ADDENDUM NO. 1

May 5, 2023

**PROJECT: 2023 Curb Installation and Replacement Contract
Village of Hastings-on-Hudson**

Sheldon Avenue

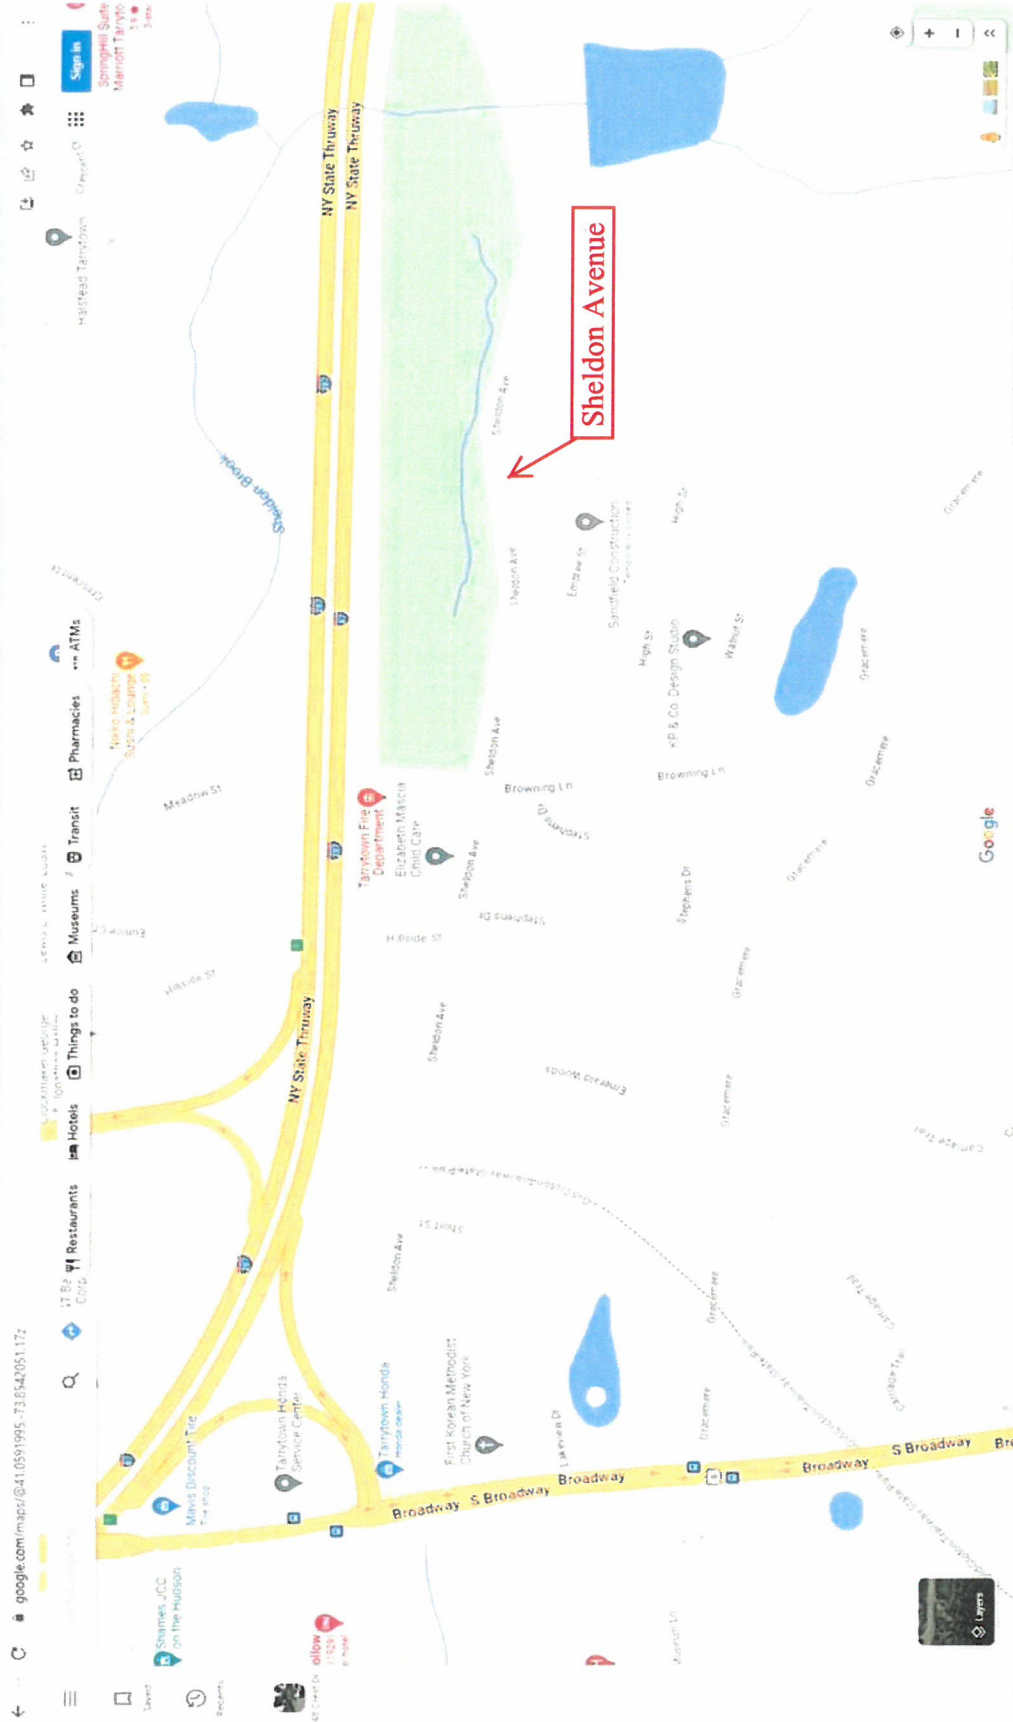
- 9) Locations of work for Ardsley and Hastings were provided. Please provide schematic drawings for the other locations.

Response: A location map for the Village of Tarrytown is attached. Curbs will be installed in the Village of Irvington on Hamilton Avenue, Clifton Place, and East Sunnyside Lane. Curbs will be installed in the Village of Elmsford on Chester Avenue from Hartsdale Road to Fairmont Street.
